SAFETY ALERT (SA)

BULLETIN : SA-22-01

SYSTEM : Hydraulic/Electric

AFFECTED TANKS : All Spray King® Tanks with stainless steel hydraulic manifold box installed.

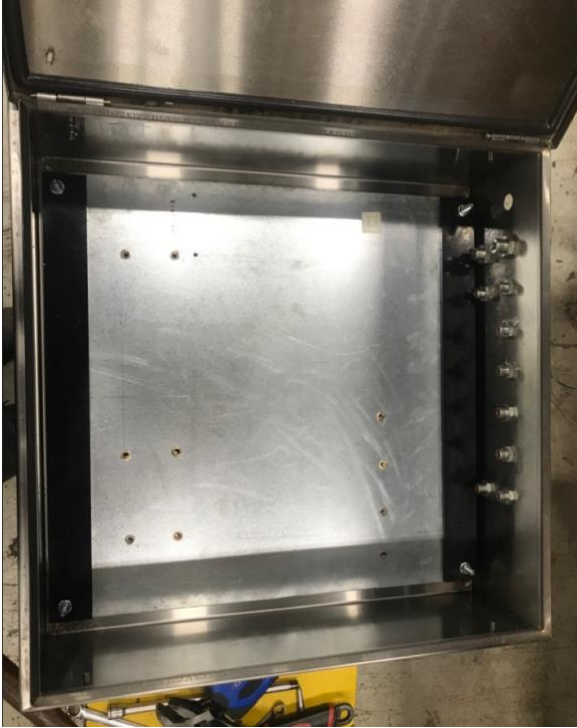
REASON : Back plate unable to hold weight of installed manifold and solenoids when operated in rough terrain.

One time inspection for presence of stainless-steel box. When present, open box and check condition of back plate where the plate is secured by the four nuts (Pic 1) . No damage or should be present

When back plate, studs, or nuts did fail, manifold assembly can fall from opened box (Pic 2). Keep the area clear and always wear appropriate Personal Protective Equipment (PPE), including eye protection, gloves, and long sleeves to prevent cuts due to sharp edges and objects.

Installation of ¼" steel straps (Pic 3) to support the weight of the back plate with manifold and solenoids. Please contact HOLT Manufacturing, 844.465.8634, for detailed information.
